**ADDENDUM NO. D-3**

**INDIANA UNIVERSITY SOUTHEAST SIDE RESIDENCE HALL**  
**BLOOMINGTON, INDIANA**  
**IU Project No. 20106837**  
**MSKTD Project No. 5804**  
**February 3, 2012**

SHEET NUMBER D1.060

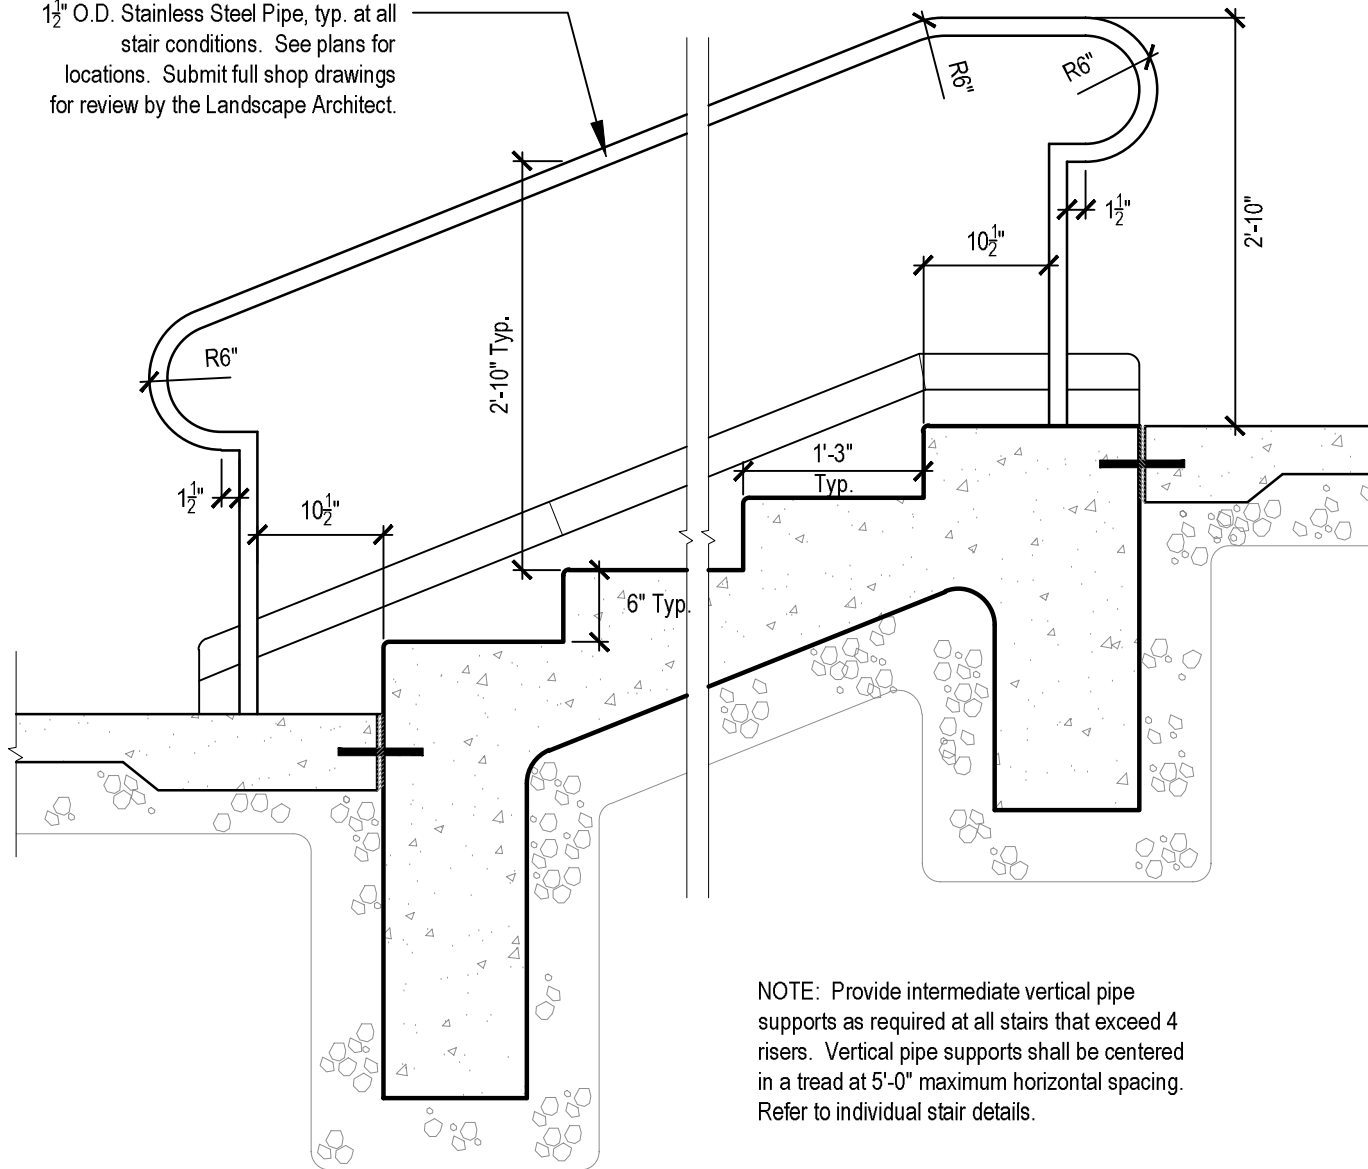
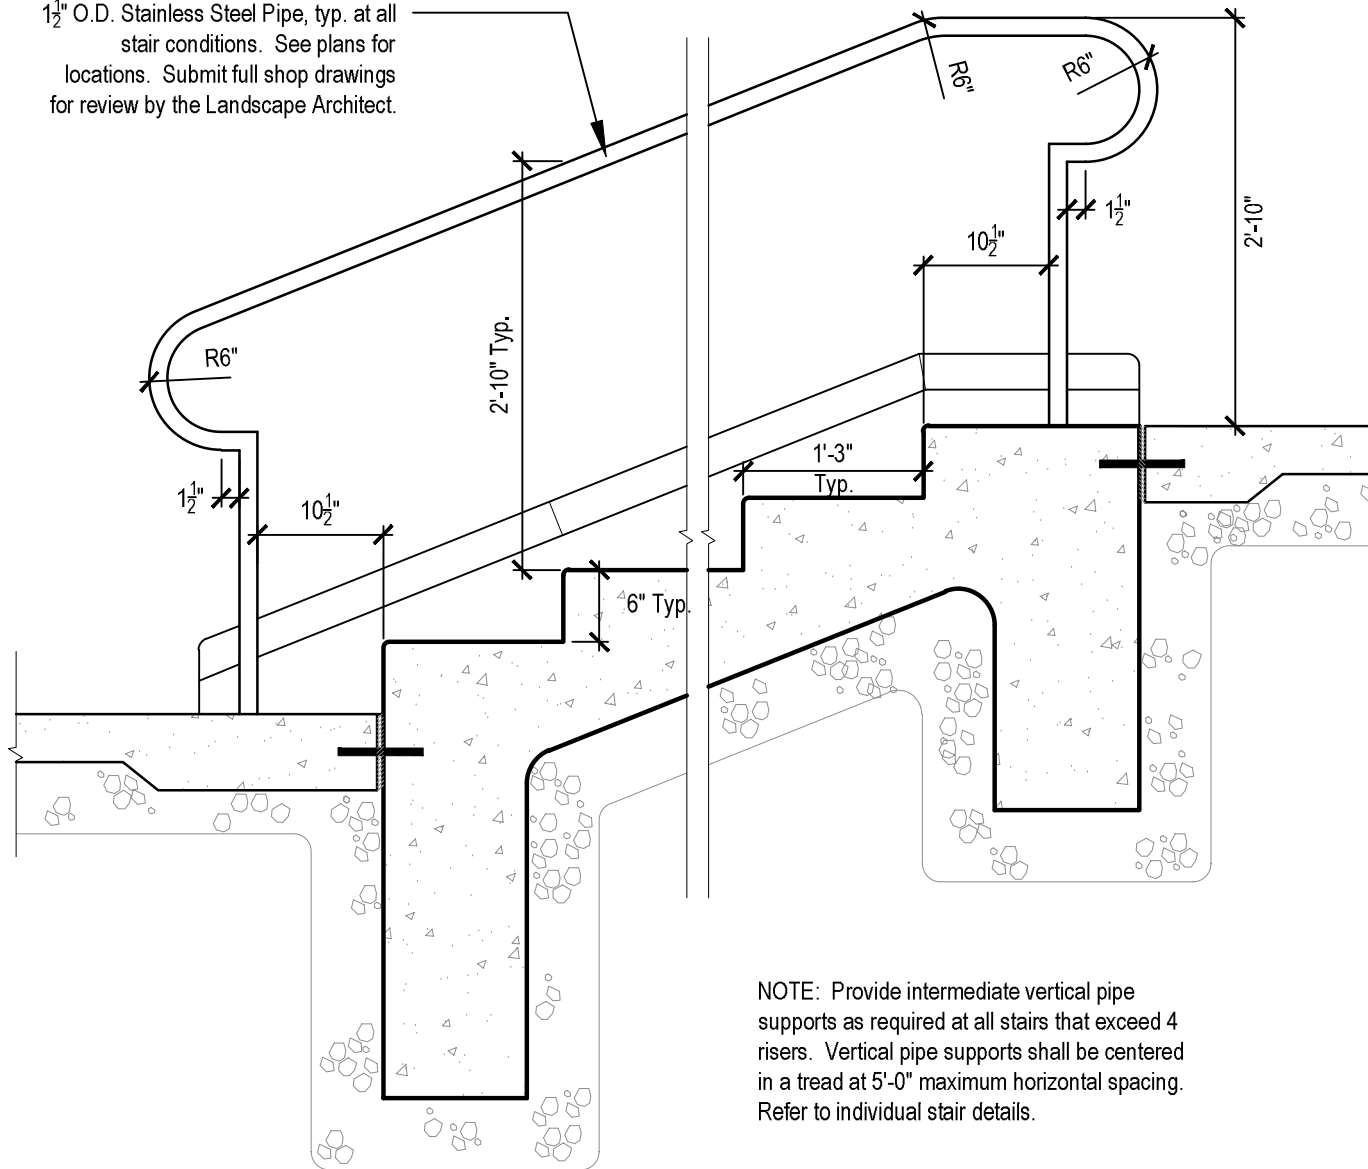
D3.20	Drawings Sheet L2.1	ADD the following note to the drawing:  NOTE: All <b>straight</b> control joints shown in concrete walks and plazas shall be sawn. All <b>curved</b> control joints shall be tooled. Provide expansion joints in all locations indicated by 'ej'. Refer to detail 13/L6.0.
D3.21	Drawings Sheet L4.0	ADD the following note to the drawing:  NOTE: All control joints indicated in the South Plaza shall be sawn. Refer to Sheet L2.1 for expansion joint locations.
D3.22	Drawings L2.0	MODIFY the Key Plan as indicated in the attached Drawings D1.056a through D1.056f. <i>(Note: This was Item D1.56 from Addendum D-1; the attachments are being reissued due to a printing error in Addendum D-1.)</i>
D3.23	Drawings 5/L6.4	ADD the attached Drawing D1.060, "Typical Stair Handrail." <i>(Note: This was Item D1.060 from Addendum D-1; the attachment is being reissued due to a printing error in Addendum D-1.)</i>

D3.42

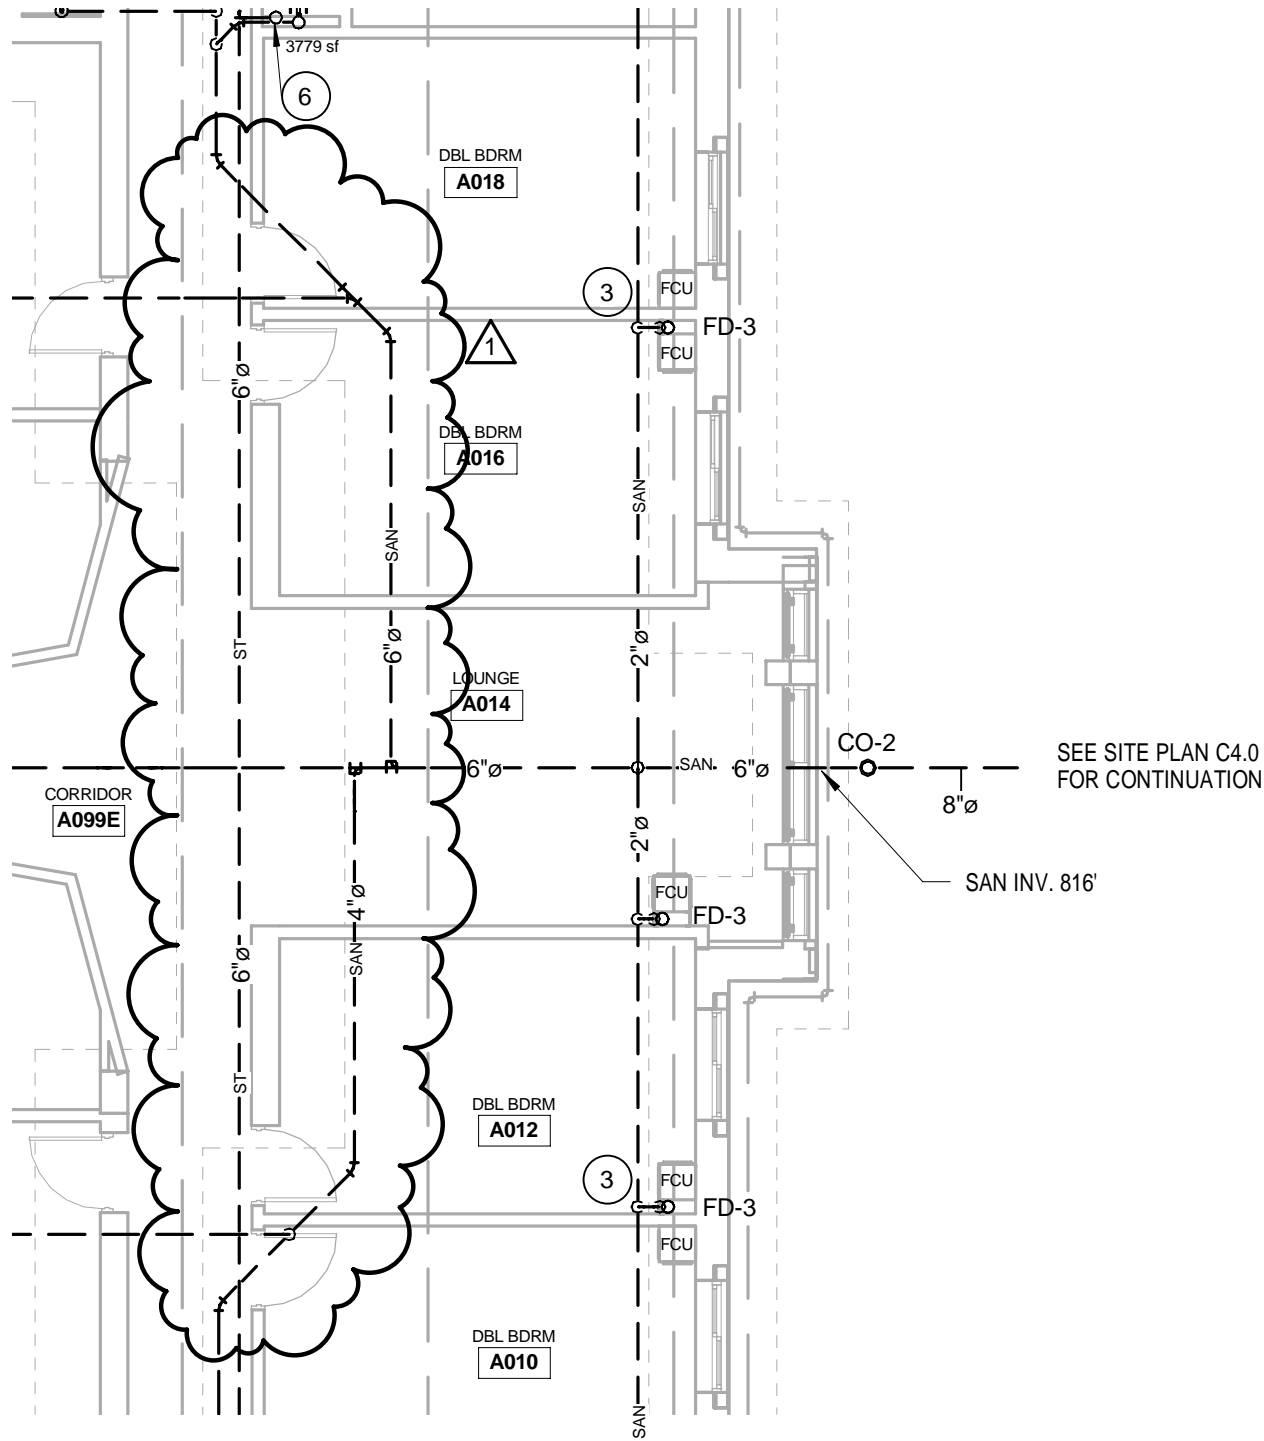
D3.41	Drawings M5.1, M6.1, M6.3	<p>Refer to sheet M6.3 "FCU Piping Detail", sheet M6.1 Stacked Heating and Cooling Coil details and schedules M5.1.</p> <p>As a clarification: The FCU piping detail on M6.3 applies to the vertical high rise fan coil units exposed in student rooms and in areas such as Study and Lounges. Vertical high capacity fan coils and horizontal fan coils shall be piped (external to the FCU) according to the coil piping details on M6.1 less the "stacked feature" and the requirement for a coil pump.</p>
D3.42	Drawings M5.2	<p>Replace AIR HANDLING UNIT SCHEDULE with Attachment D3.42.</p> <p>Add to AHU GENERAL NOTE "D": ONE GAUGE FOR PREFILTER, ONE FOR FINAL FILTER.</p> <p>Add to ENERGY RECOVERY VENTILATION AIR HANDLING UNIT SCHEDULE with Attachment D3.42.</p> <p>Add to ERU GENERAL NOTES "D": ONE GAUGE FOR PREFILTER, ONE FOR FINAL FILTER.</p> <p>Add ERU GENERAL NOTE "E": SCHEDULED RETURN FAN CFM'S REPRESENT AIRFLOW FROM BUILDING SPACES (CFM-R) AND CFM EXHAUSTED FROM THE UNIT (CFM-E). THE DIFFERENCE REPRESENTS PURGE/SEAL CFM AT THE ENERGY RECOVERY WHEEL.</p> <p>Replace RETURN FAN SCHEDULE with Attachment D3.42.</p>

- REVISION TO SHEET M5.1
- ADDED BHP FOR AHU SUPPLY AND RETURN FANS
  - MODIFIED AHU GENERAL NOTE "D".
  - ADDED BHP FOR ERU SUPPLY AND RETURN FANS
  - ADDED ACTUAL EXHAUST CFM'S (CFM-E) FOR ERU'S.
  - MODIFIED ERU GENERAL NOTE "D".
  - ADDED ERU GENERAL NOTE "E".
  - ADDED BHP TO RETURN FAN SCHEDULE.
